City of Bristol
Conservation Commission/ Inland Wetlands and Watercourses Agency

SPECIAL MEETING - WEDNESDAY, MAY 22, 2024
CITY HALL COUNCIL CHAMBERS
111 NORTH MAIN STREET
7:00 P.M.

- b. Application #2020 – Wetlands application for the restoration of the White Bridge Waterworks facility at Maltby Street; Assessor's Map 52 & 53, Lots 11, 15, 16B16A, 17, 145, 147, 149, 150 & 151; New Britain Water Department, Ramon Esponda, Deputy Director, applicant (Public Hearing Closed at May 6, 2024 Regular Meeting).

**BRISTOL CONSERVATION COMMISSION
INLAND WETLANDS AGENCY
FORM IW-2 (Application for a Wetlands Boundary Change)**

A2-2
SHEET WR-2
SCALE: 1' = 10'

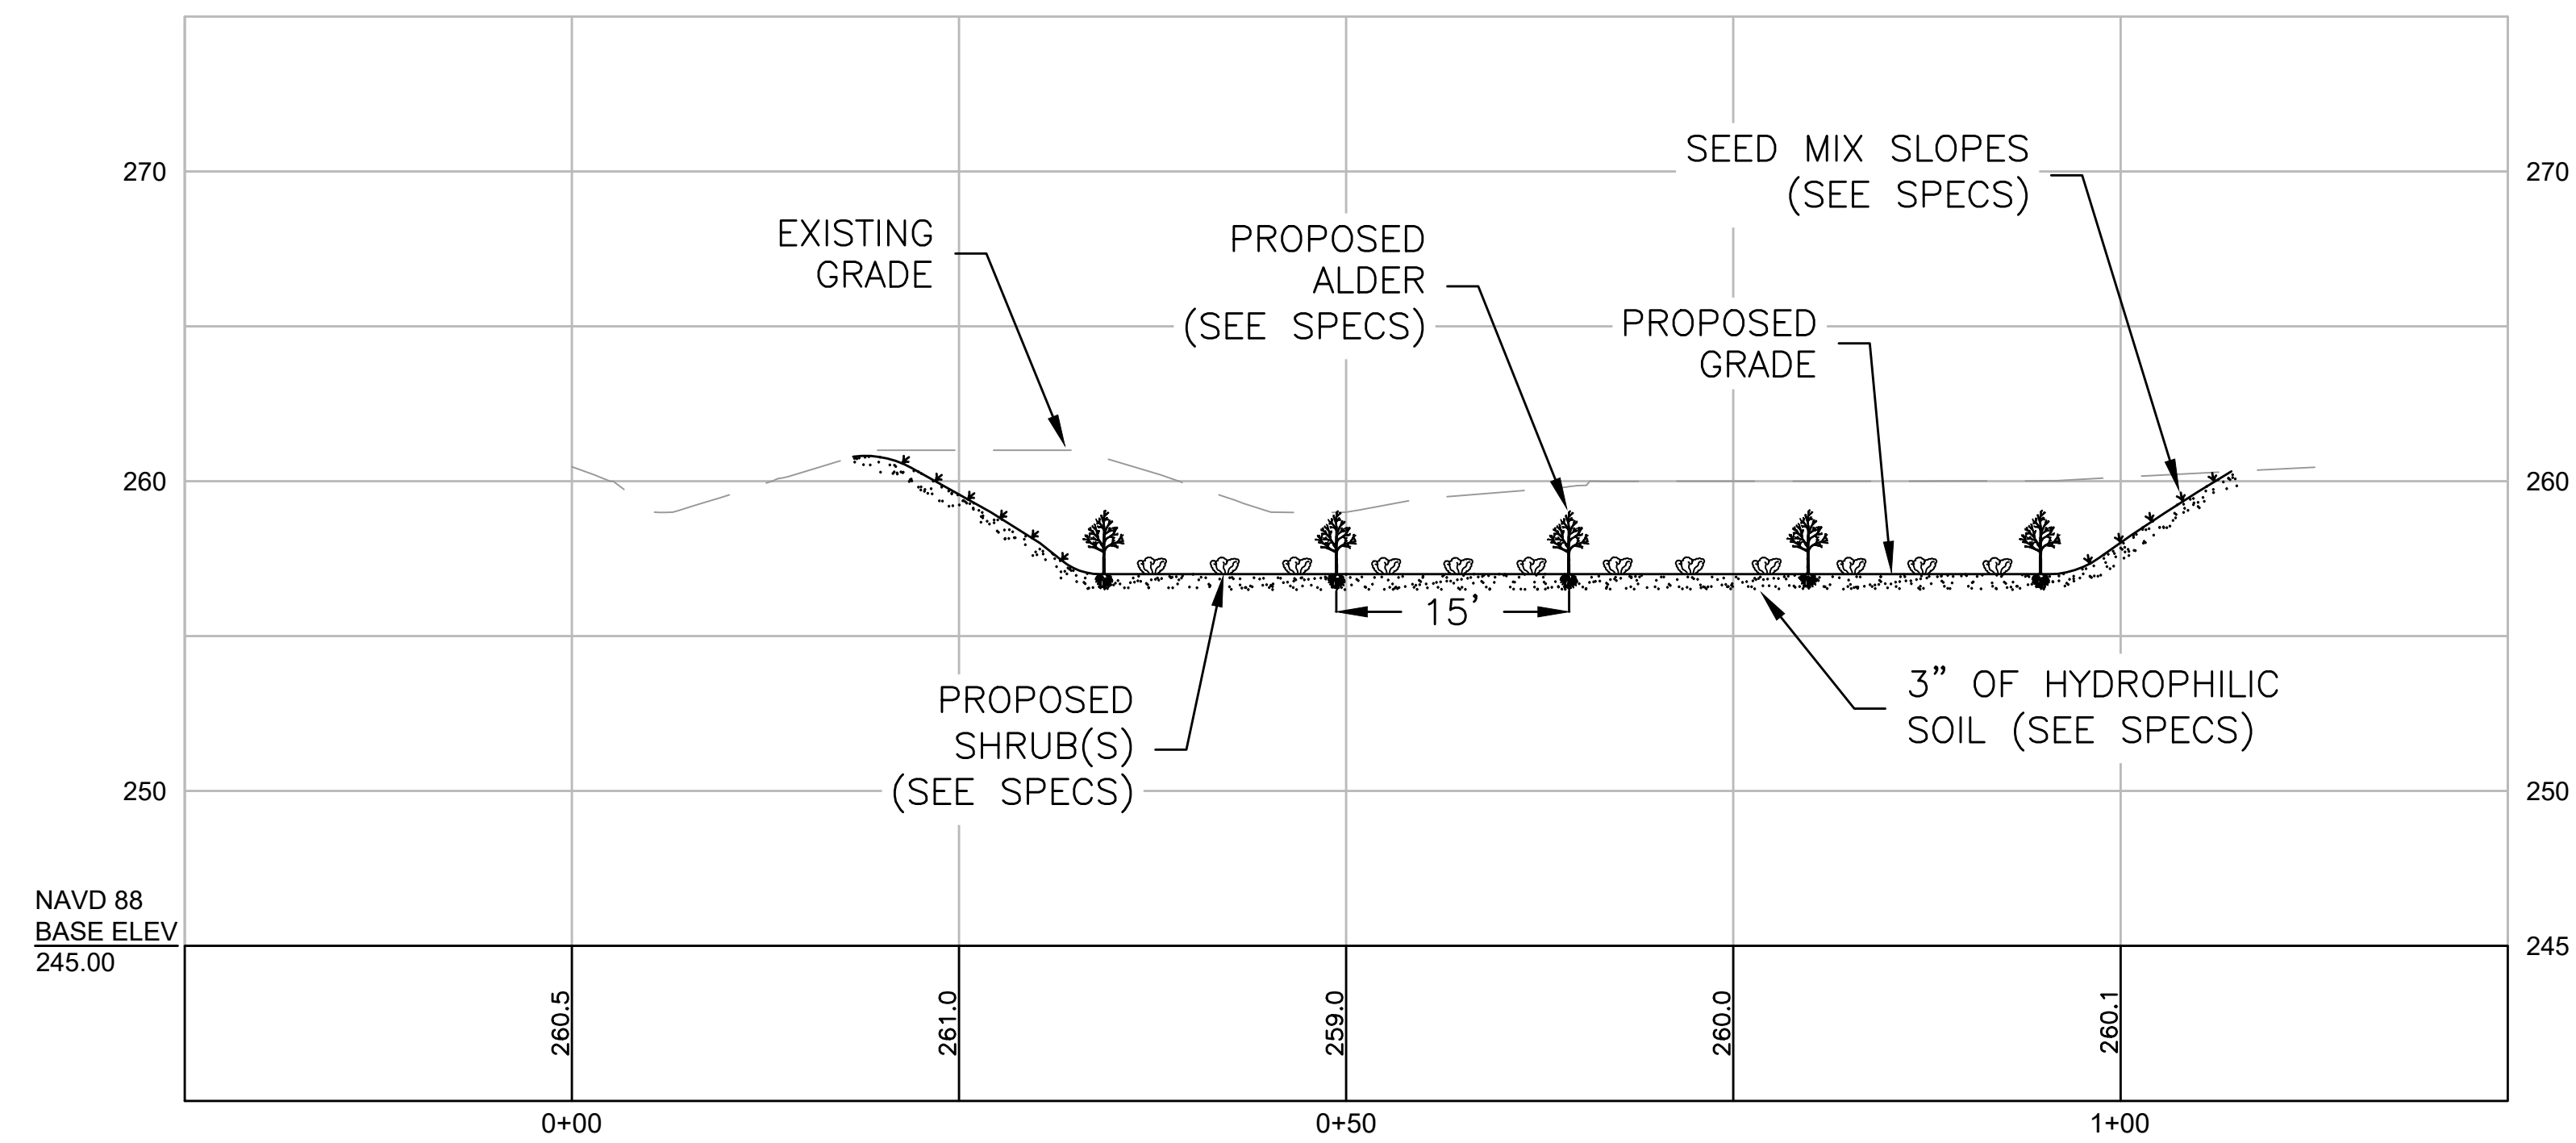
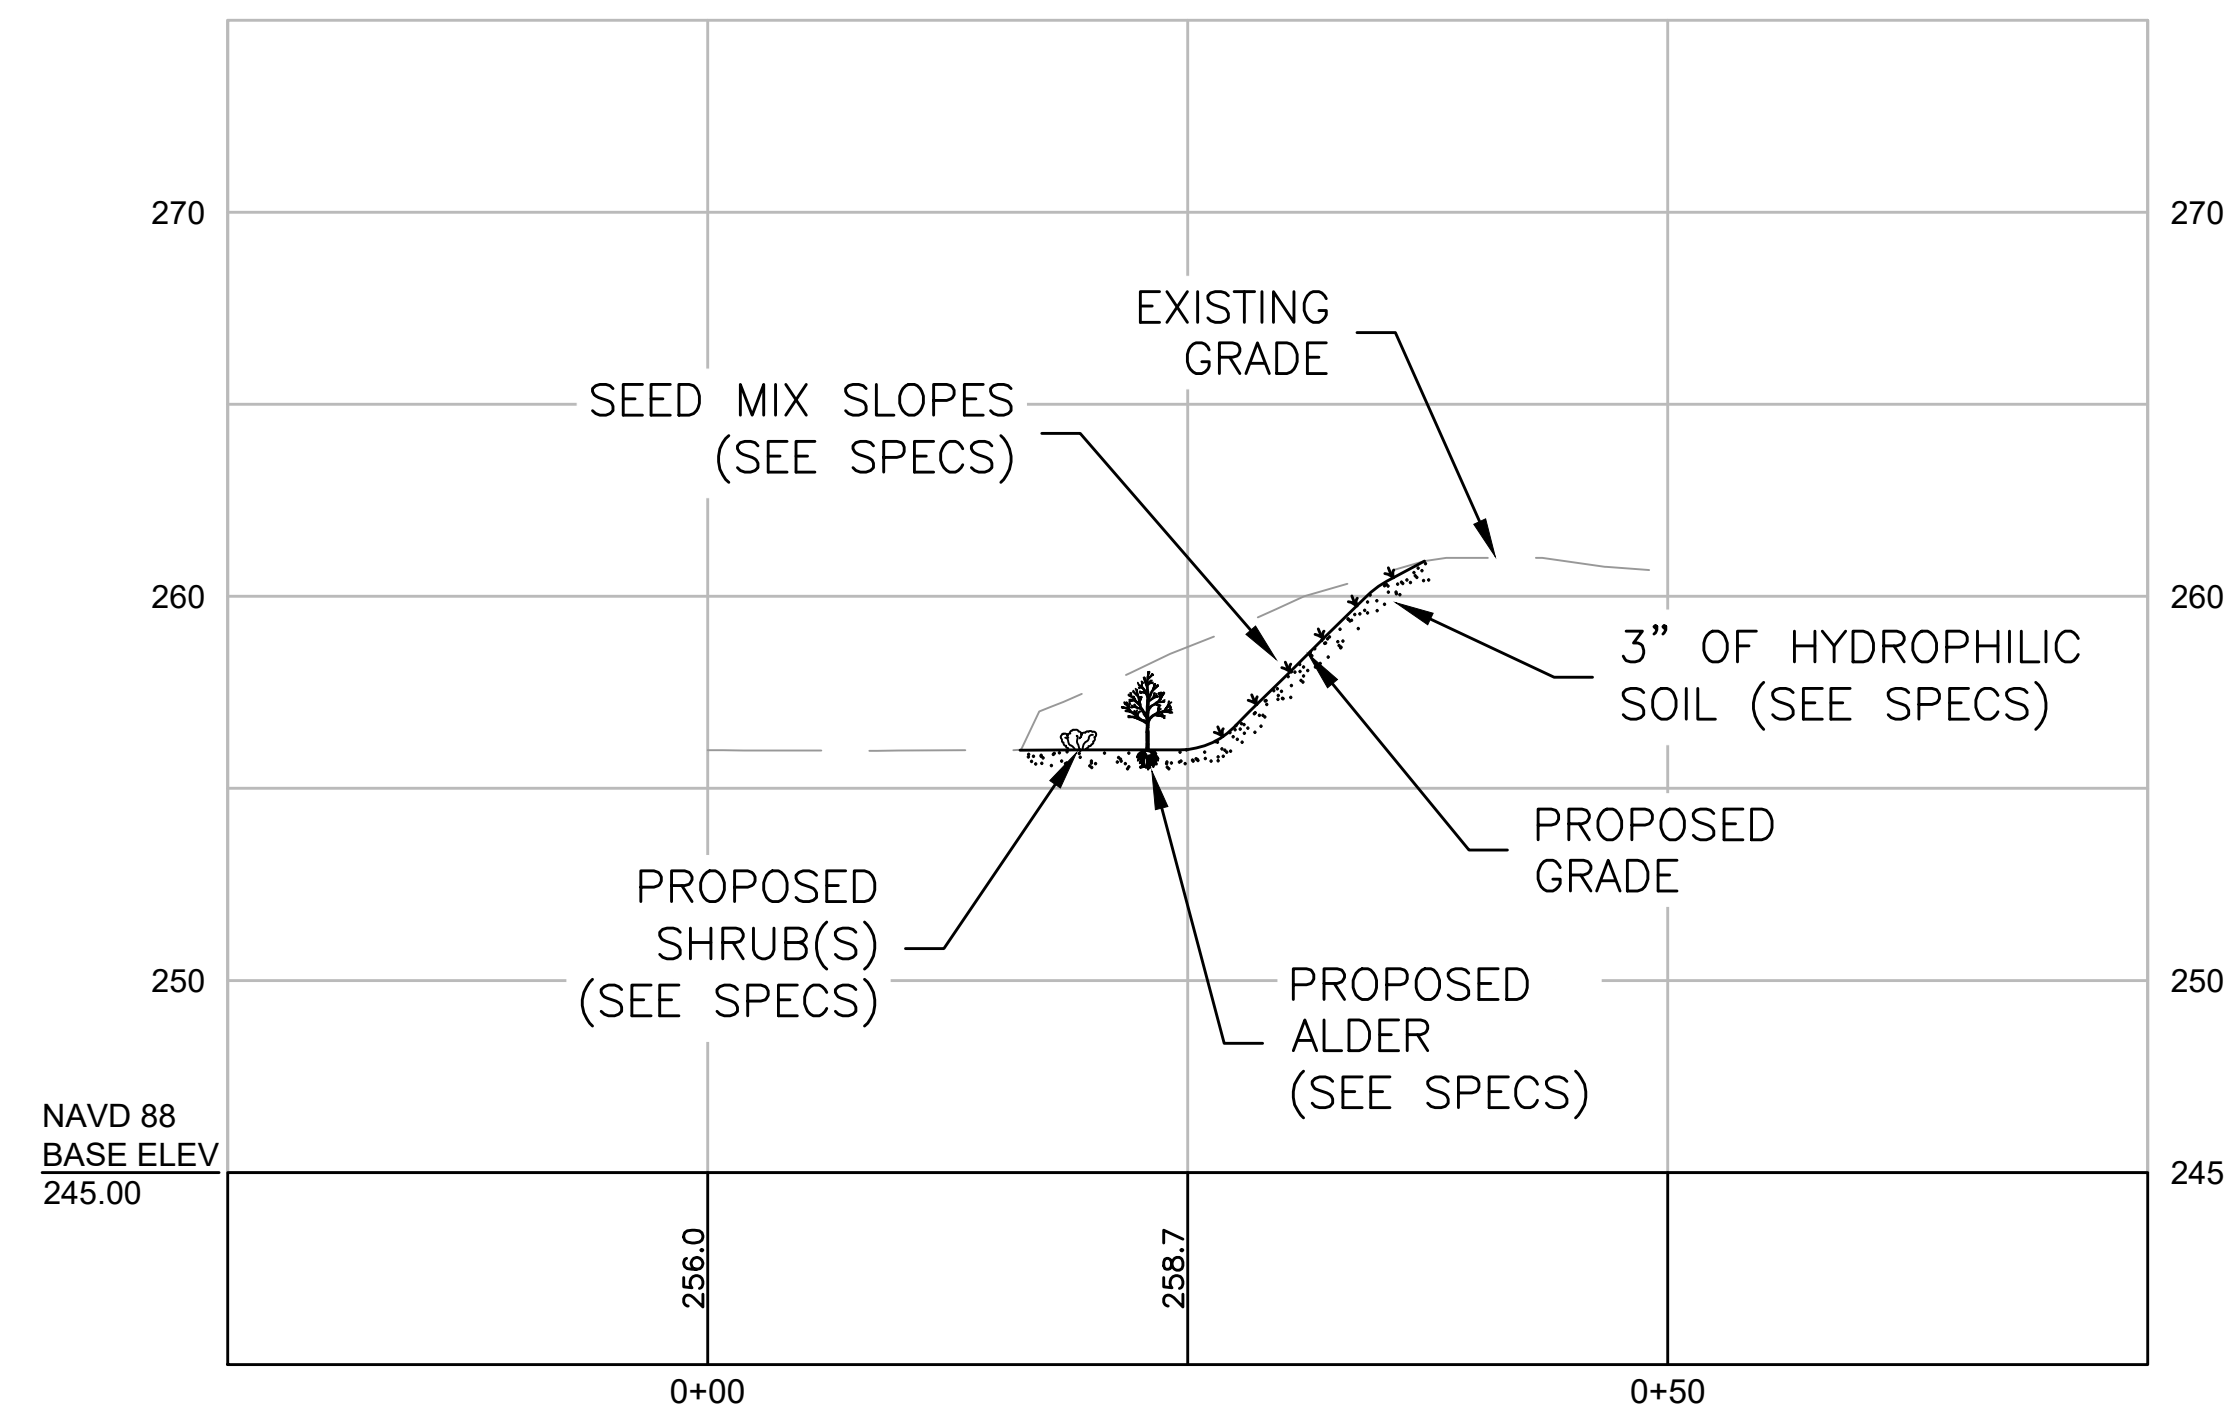
- b. On sheet WR-2, will any grading and stabilization be done for the haul/construction/access road? (The south road shows “dips” of 3’ - 4’ in the vicinity of the road narrowing for the south longitudinal section of mitigation). What is the tabulated area of impact for wetlands/upland review for these areas, including slope transitions, with a discussion of the existing land cover? Please discuss periods for invasive management and any proposed chemical use that may be needed to manage invasives in these proposed mitigation area. Due to the proximity of the wells, will chemical use be restricted? The plan calls for wetland replication of 3,057 SF to el 257 and 2,008 SF to el 256. The third area of impact/replication is not called out. What is the quantity of temporary impacts in regulated wetlands for each area’s construction? What is the anticipated surface water fluctuation to the adjacent wetlands and brook resulting from the new wells?

A4-1
SHEET WR-4
SCALE: 1' = 10'

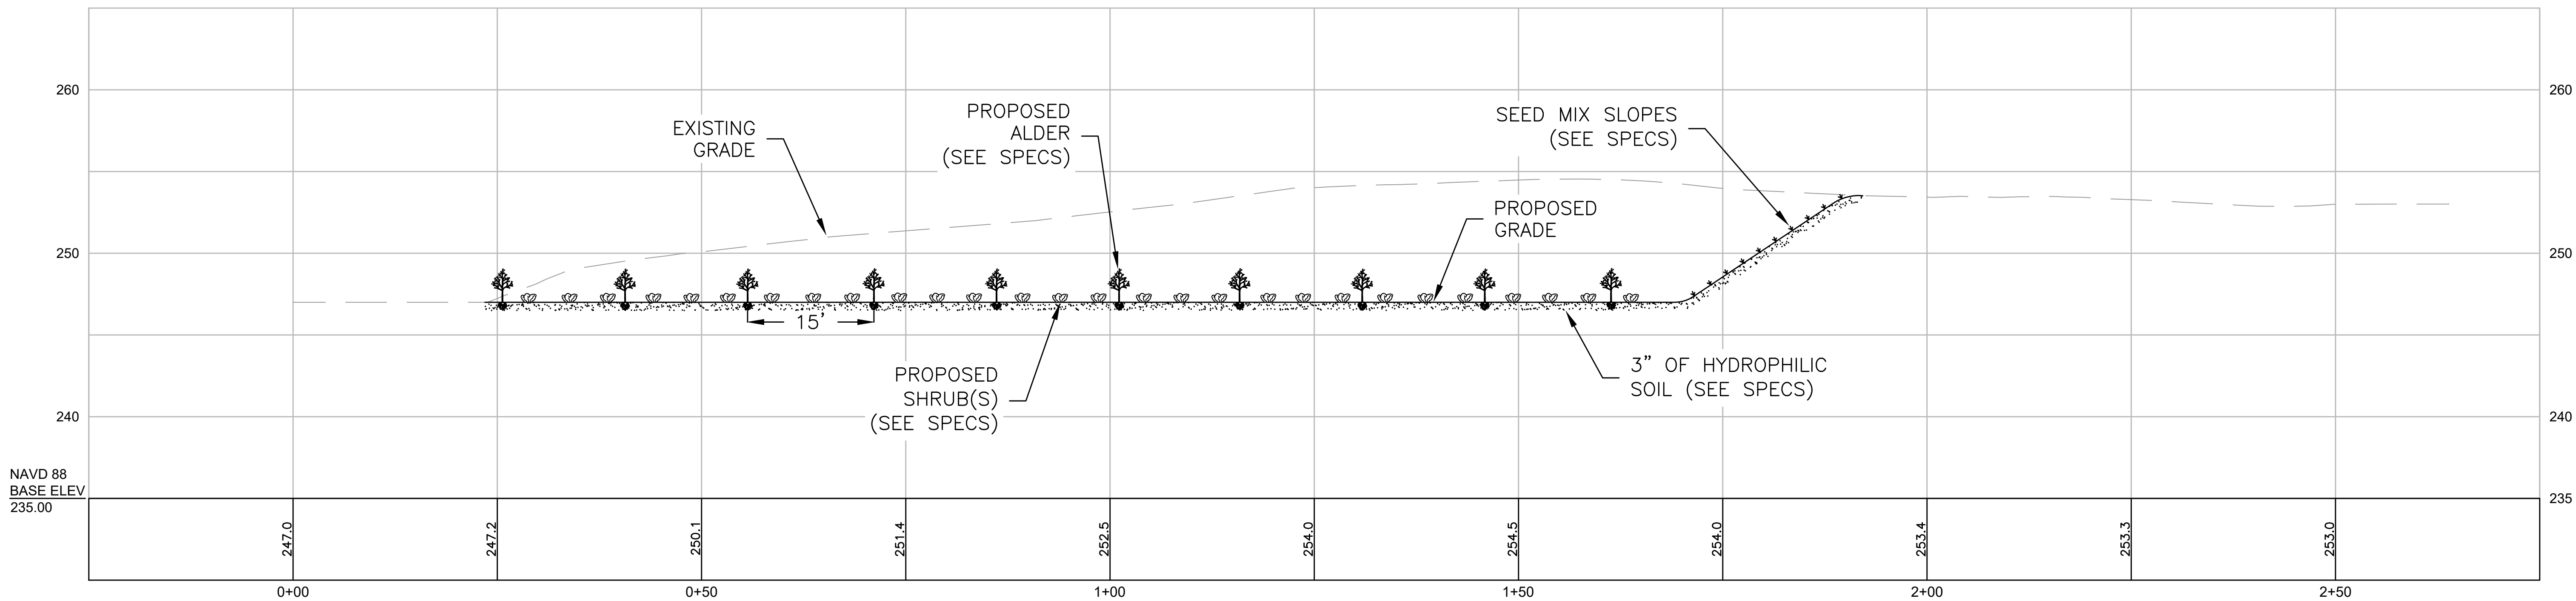
- d. On Sheet WR-4, the proposed replication area 7,000 SF graded to el 249 with an unidentified quantity of area graded to 252 and grassed (represented by Section A4-1). Please describe the existing and replacement land covers, label contours and tabulate the impacted areas, including slopes and access road, in the regulated wetland areas.
